Notice of Proposed Amendment 2016-04

Maintaining aerodrome rules

CS ADR-DSN — Issue 3

RMT.0591 — 14.6.2016

Figure C-1. Runway starter extension strip

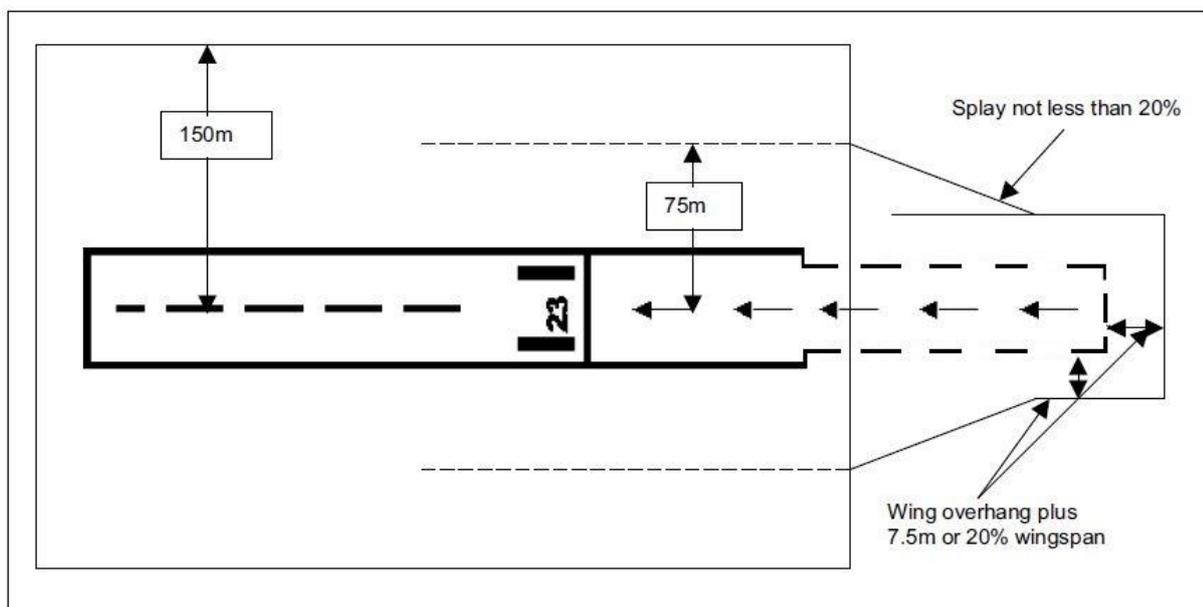
- (1) Length of the runway starter extension strip should be provided to cover wing overhang of the largest aeroplane plus a safety margin of 7.5 m or 20 % of wingspan of the largest aeroplane, whichever is greater (see Figure C-1).
- (2) Width of the runway starter extension strip should be the same as associated runway strip on its inner edge and may be reduced towards its outer edge to provide a distance from each edge of the runway starter extension to cover wing overhang of the critical aeroplane plus 7.5 m or 20 %

of wingspan of the largest aeroplane, whichever is the greater (see Figure C-1). The splay of this reduction should not be less than 20 %.

Figure L-5A. Marking of the runway starter extension

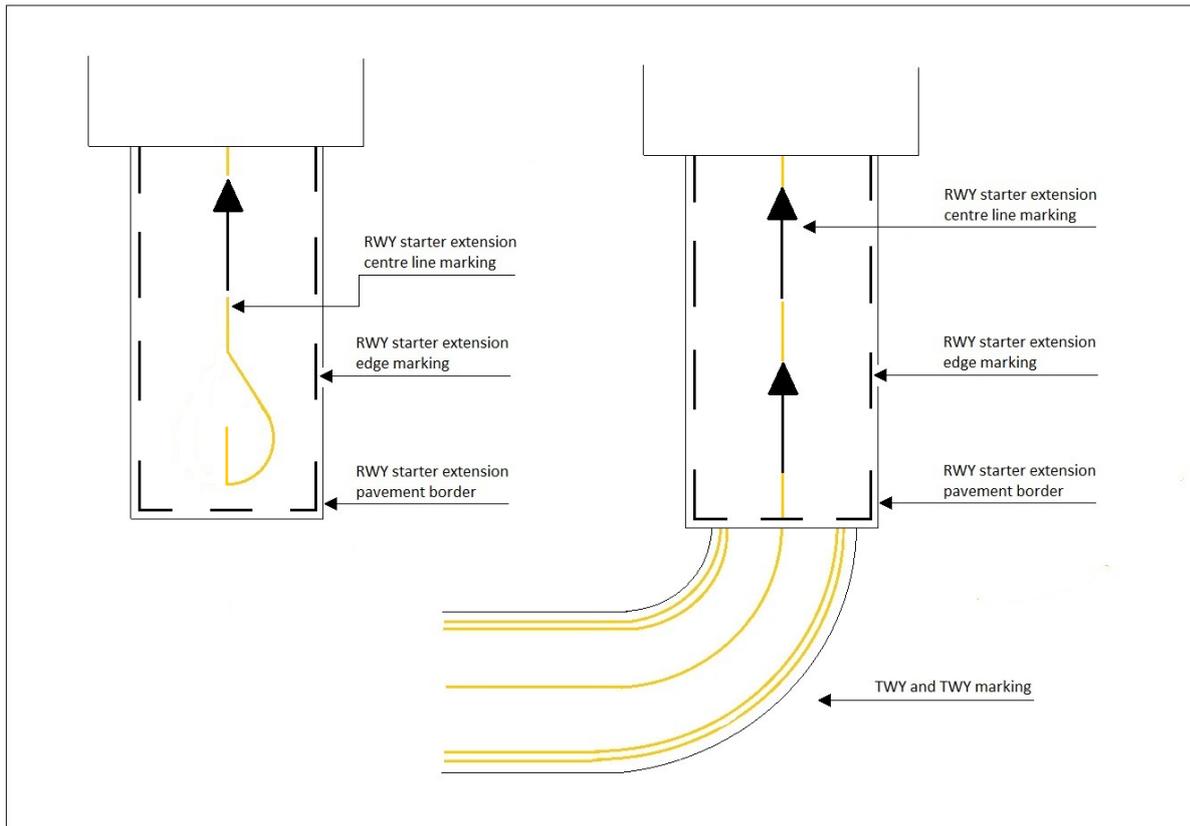
- (c) Characteristics:
 - (1) Edge marking of the runway starter extension should be dashed white line (see Figure L-5A).
 - (2) Centre line marking of the runway starter extension should be yellow and be at least 15 cm in width.

- (4) The runway starter extension should be provided with arrows conforming to Figure L-3(B) showing in the direction of take-off.

Figure L-6. Enhanced taxiway centre line marking

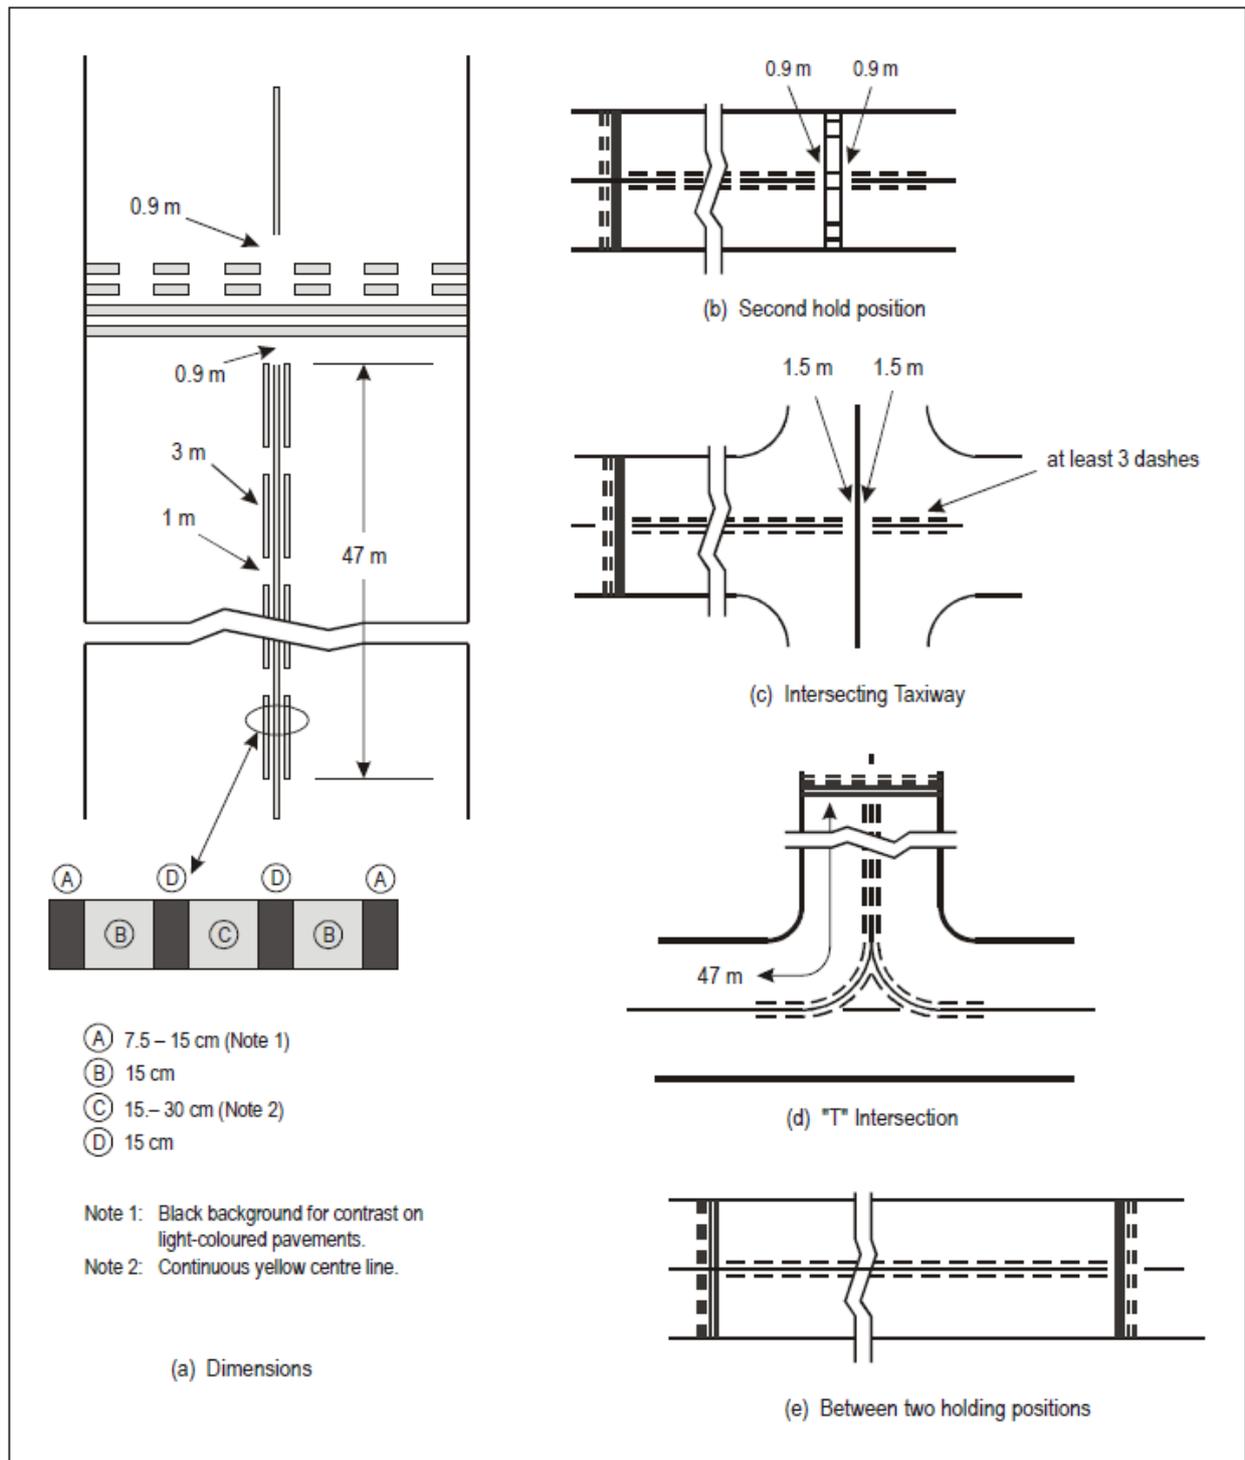
The requirements of enhanced taxiway centre line marking are updated in line with the ICAO Annex 14 (Amendment 11). The proposed amendments adopt a slightly different wording, but the meaning remains the same. At the same time they correct the extend of the enhanced taxiway centre line (47 m instead of 45 m due to mathematical errors) and the requirements concerning its location which become more detailed, but without having any impact.

- (b) **Characteristics:**
- (1) Enhanced taxiway centre line marking should be as shown in Figure L-6. An enhanced taxiway centre line marking should extend from the runway-holding position Pattern A (as defined in Figure L-5) to a distance of up to 47 m in the direction of travel away from the runway (see Figure L-6(a)).

position marking for at least three dashed line segments or 47 m from start to finish, whichever is greater (see Figure L-6(b)).

- (3) If the enhanced taxiway centre line marking continues through a taxiway/taxiway intersection that is located within 47 m of the runway-holding position marking, the enhanced taxiway centre line marking should be interrupted 1.5 m prior to and after the point where the intersected taxiway centre line crosses the enhanced taxiway centre line. The enhanced taxiway centre line marking should continue beyond the taxiway/taxiway intersection for at least three dashed line segments or 47 m from start to finish, whichever is greater (see Figure L-6(c)).

[Editorial Note: Remove exiting Figure L-6]

[Editorial Note: Insert new Figure L-6]

Figure L-9. Mandatory instruction marking

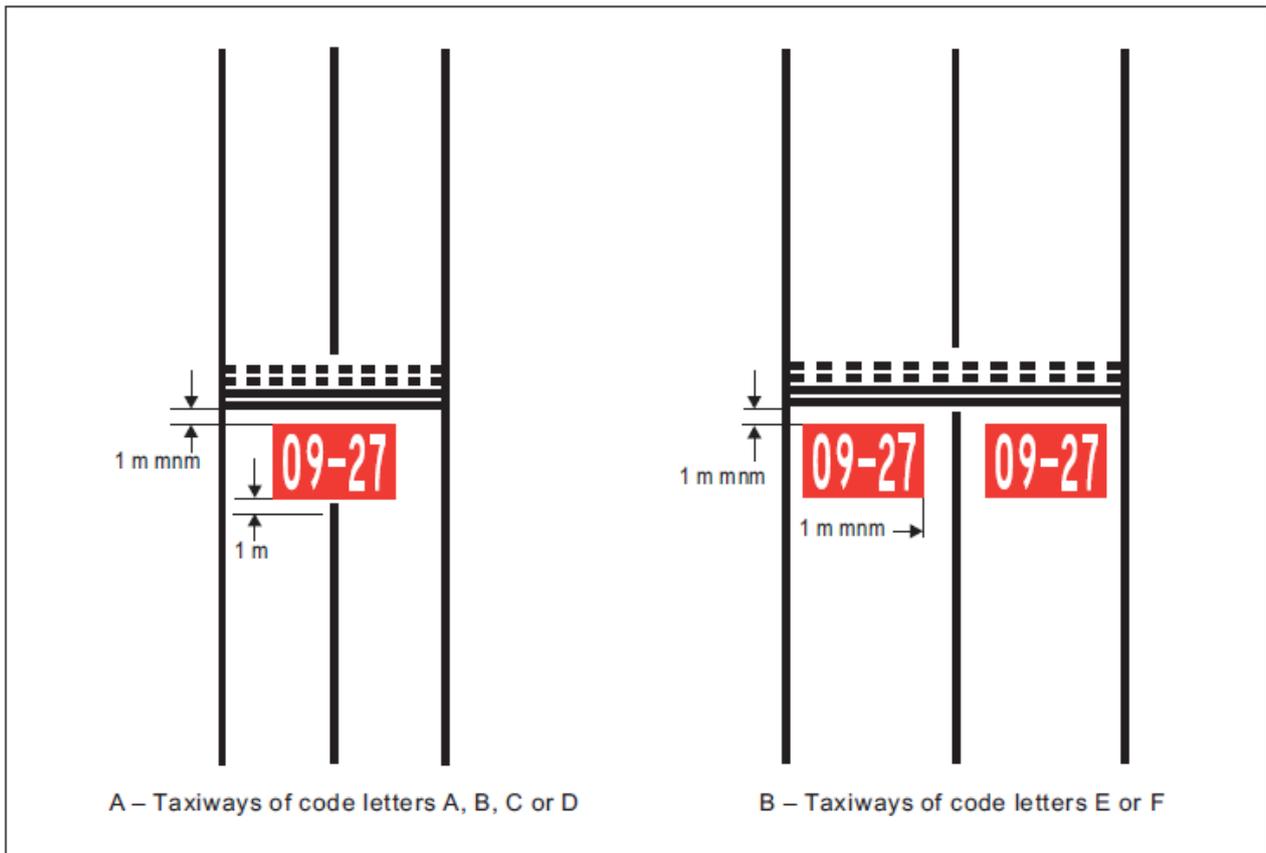
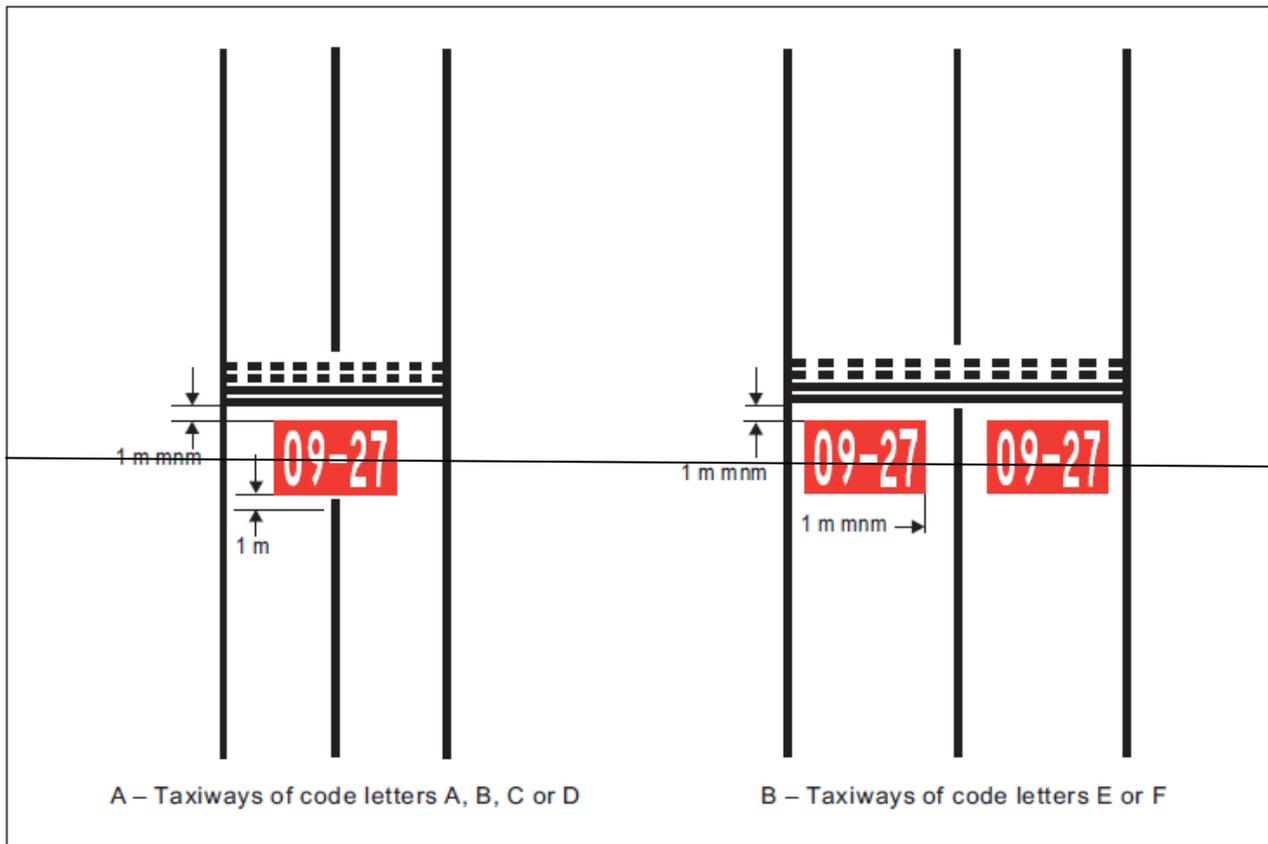
The unchanged Figure L-9 is moved to the appropriate position.

The unchanged Figure L-9 is removed to the appropriate position.

Figure M-2. Precision approach Category I lighting systems

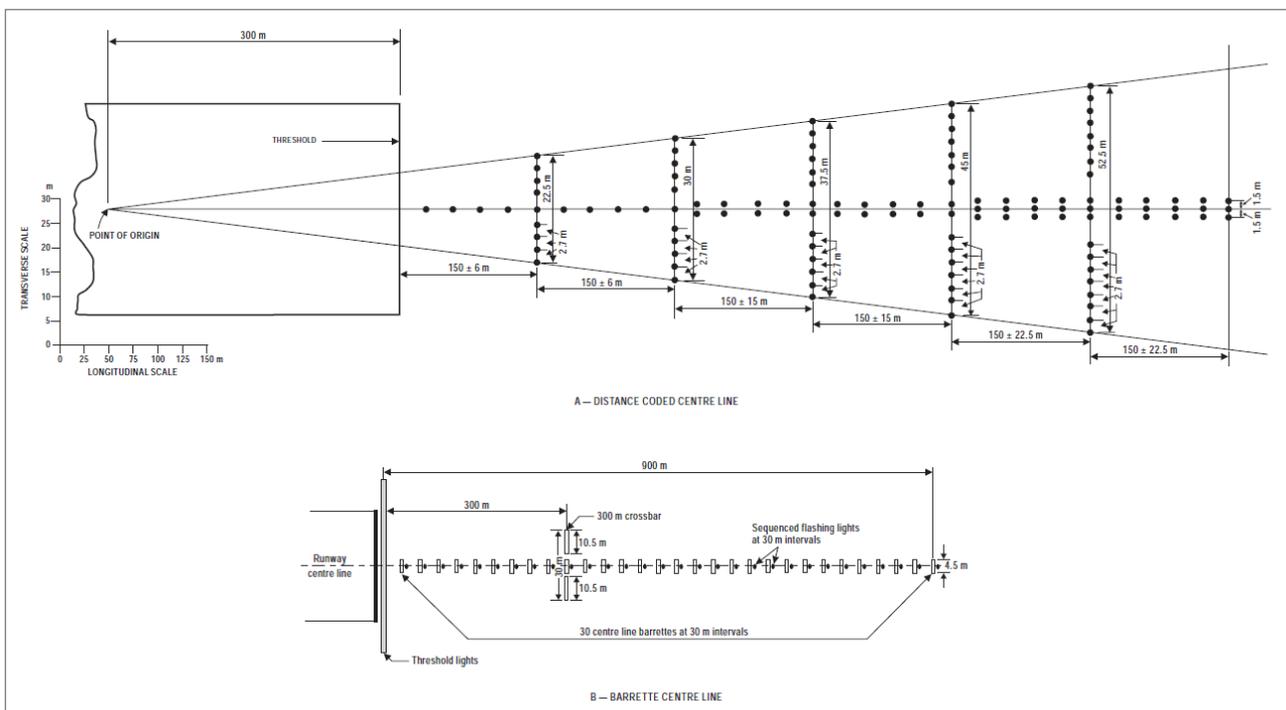
For better clarification, in paragraph (b) (1) the reference to the Figure M-2 and corrections of typos are provided.

In the title of Figure M-2 correction of a typo is provided.

- (1) General: A precision approach eCategory I lighting system should consist of a row of lights on the extended centre line of the runway extending wherever possible, over a distance of 900 m from the runway threshold with a row of lights forming a crossbar 30 m in length at a distance of 300 m from the runway threshold (see Figure M-2).

Figure M-4. Siting of PAPI and APAPI

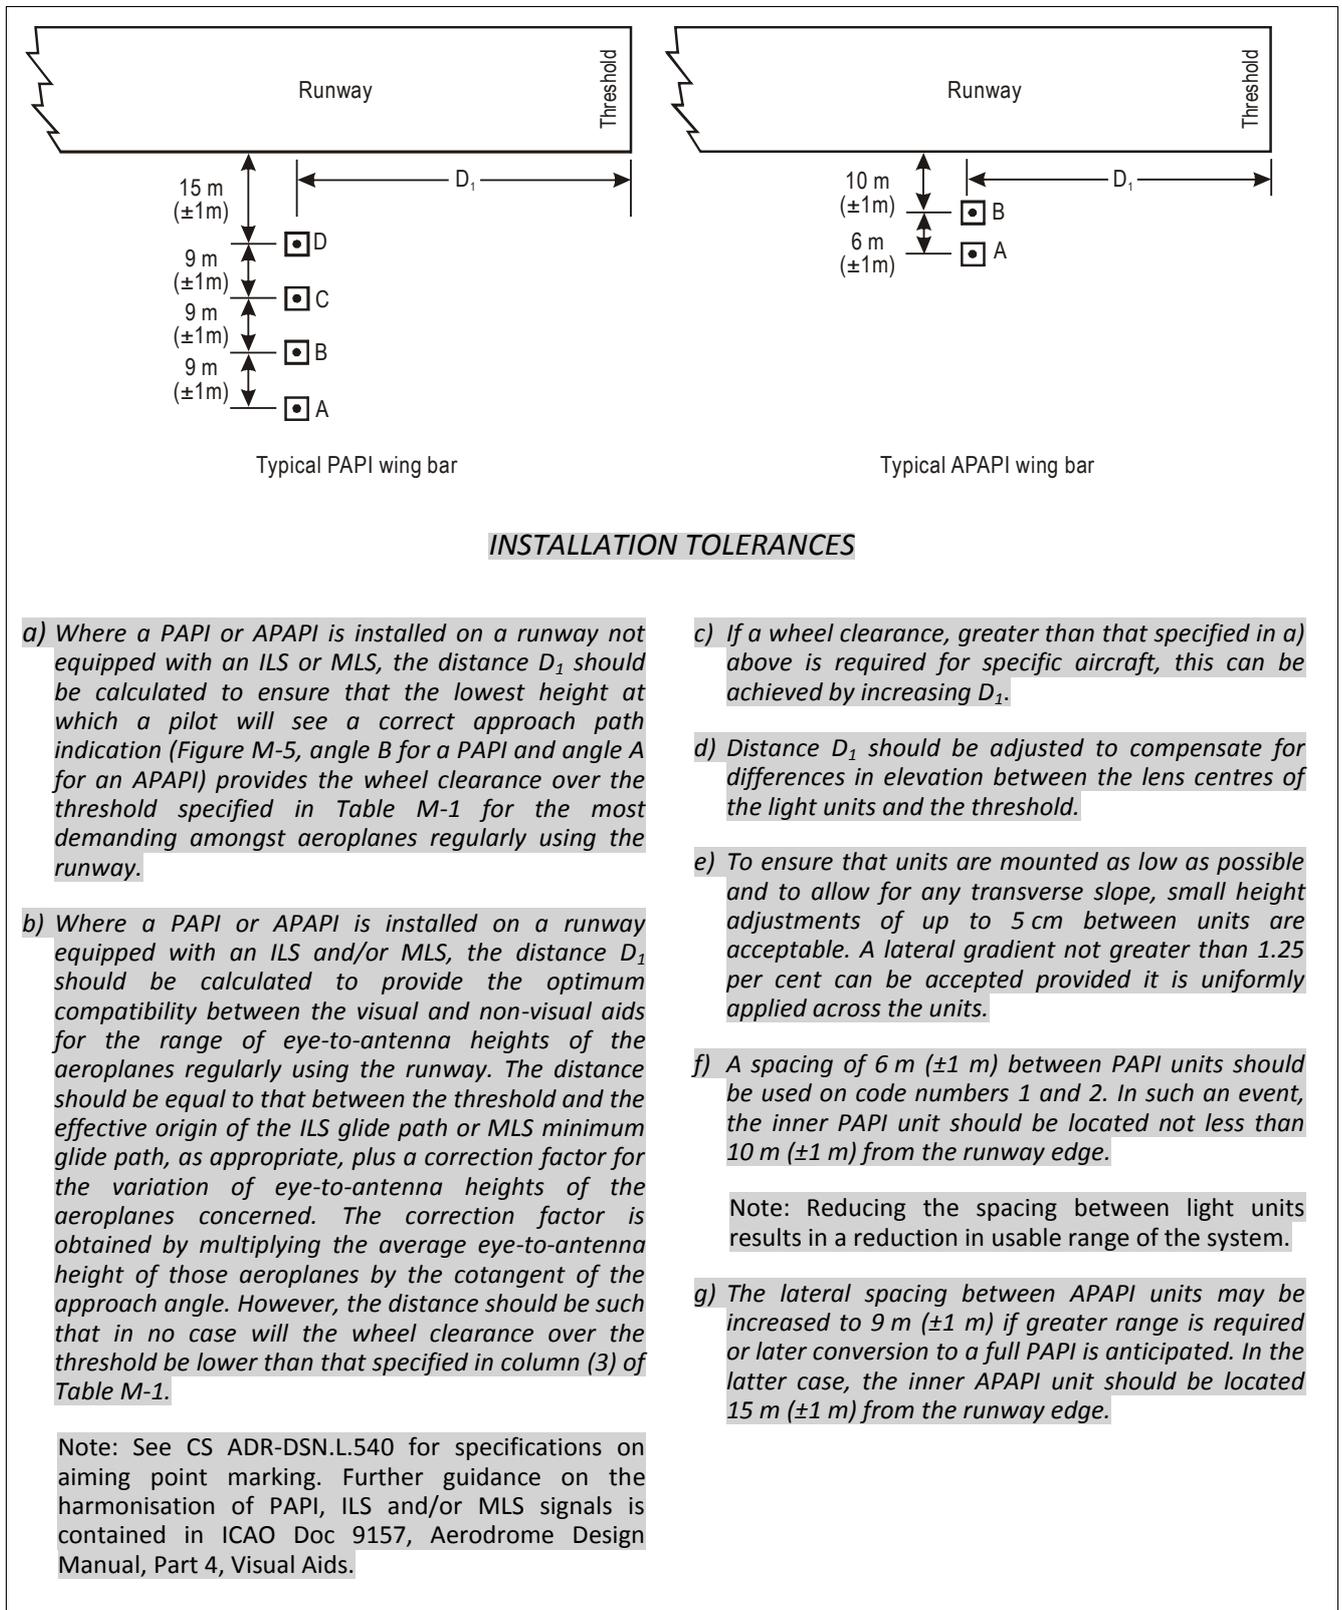
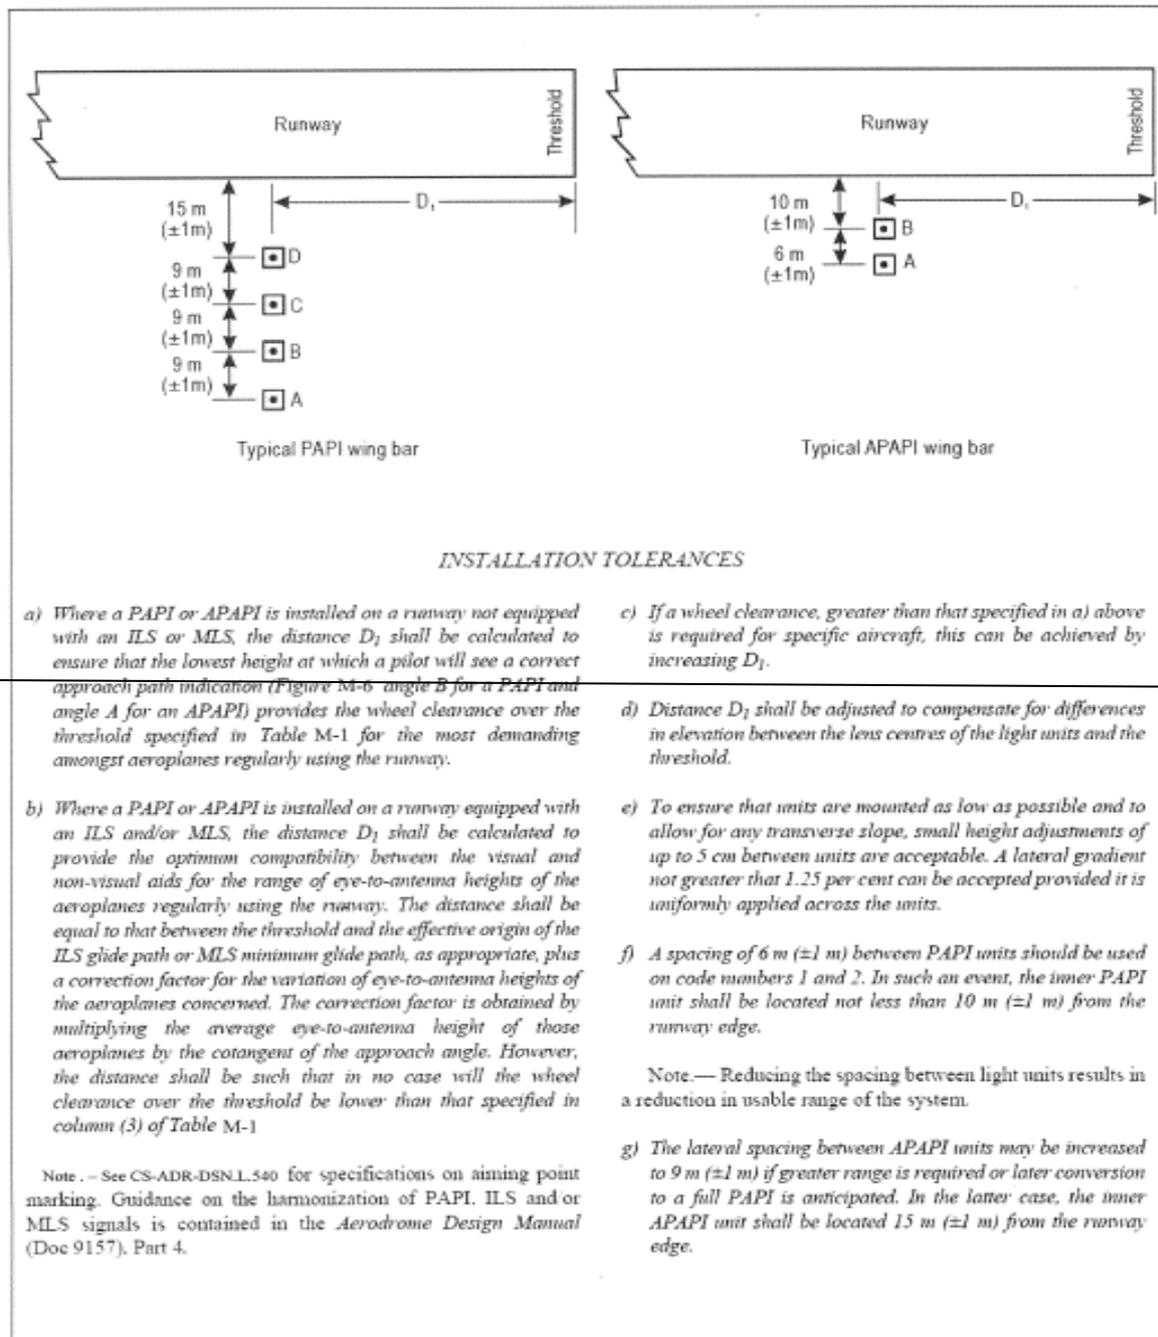
A new Figure M-4 is provided with better quality, without any change to its content.

[Editorial Note: Insert new Figure M-4]

[Editorial Note: Remove existing Figure M-4]
